NORTHEAST NUCLEAR ENERGY COMPANY'S
RESPONSE TO
JACK R. BENJAMIN & ASSOCIATES'
REVIEW OF THE REVISED
MILLSTONE UNIT NO. 3 PROBABILISTIC
SAFETY STUDY SEISMIC FRAGILITY
May 4, 1984

DECEMBER, 1984

MILLSTONE NUCLEAR ENERGY COMPANY'S
RESPONSE TO REQUEST
FOR ADDITIONAL INFORMATION
QUESTION 720.92

REQUEST FOR ADDITIONAL INFORMATION
MILLSTONE NUCLEAR POWER STATION, UNIT 3

FIGURE 720.92-1. SCALE FACTOR, F_H VERSUS DURATION

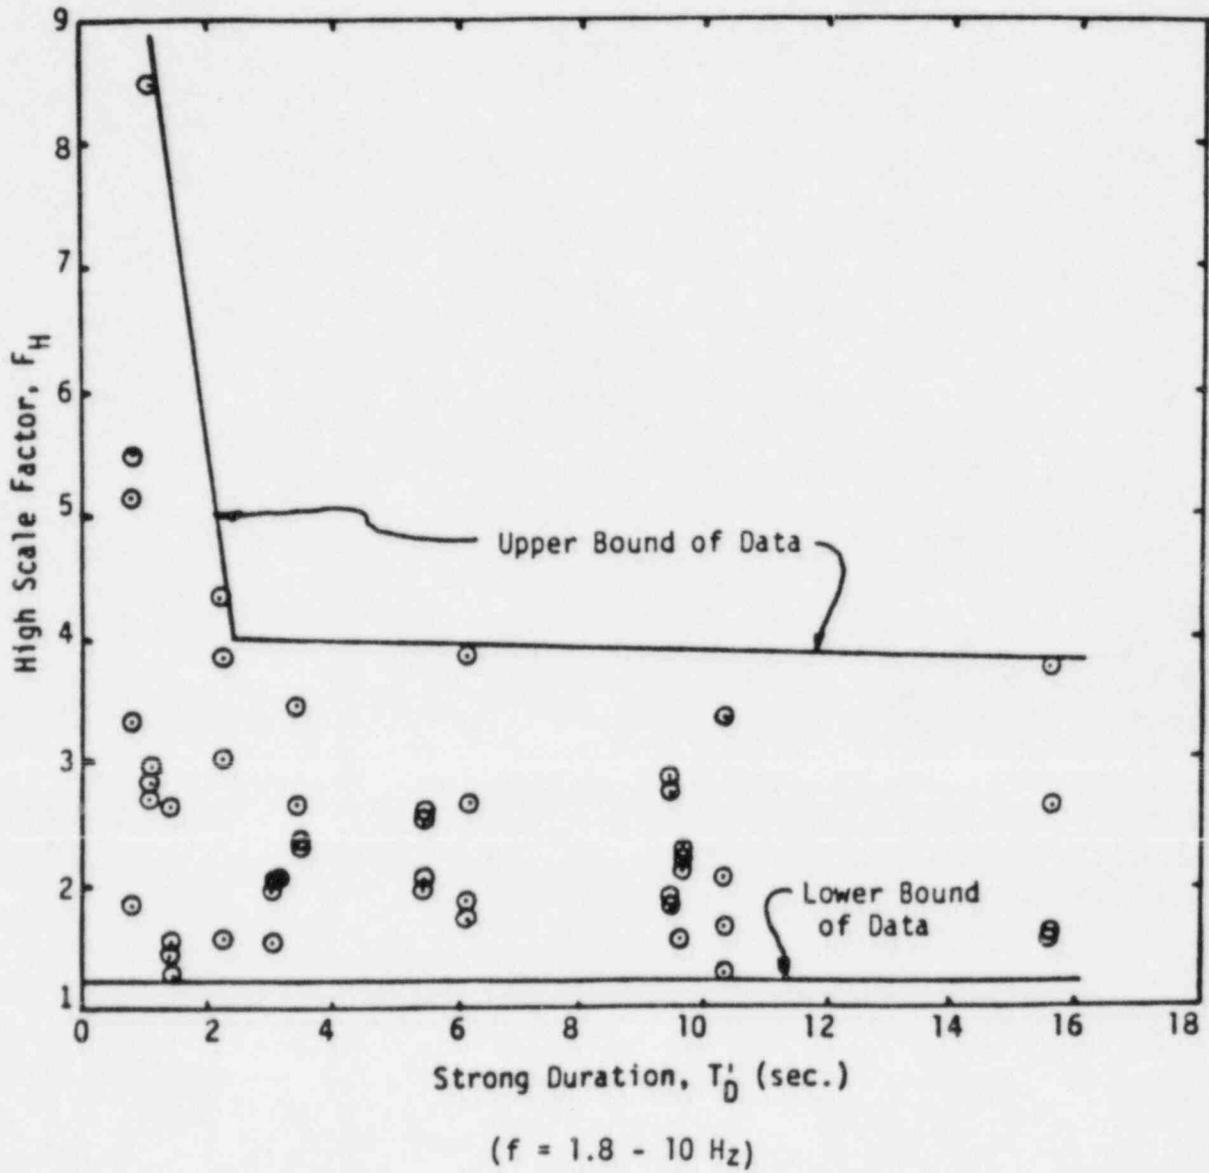
The staff also needs additional information on your statement that C_D , the correction factor on ductility, is considered to be frequency independent.

- (3) Give evidence to support your statement that C_D is considered to be frequency independent. Provide the specific C_D factors associated with the 8.54 HZ model structure frequency for Tables 4-4 and 4-5 included in the Structural Mechanics Associates seismic fragility analysis.
- (4) If the values of C_D from question (3) are lower than the C_D you have used ($C_D = 1.3$), provide justification for your assumptions.

The factor of safety resulting from ductility effects, F_μ , is dependent on both duration and spectral shape. Figure 720.92-1 is reproduced from Reference 3 and clearly shows the effect of strong motion duration for a ductility ratio of approximately 4.3. However, F_μ is most strongly influenced by the spectral shape and the frequency of the structure. Table 720.92-1 is also reproduced from Reference 3 and shows the F_μ factors for the various earthquake records and structure frequencies for the 4.3 ductility ratio.
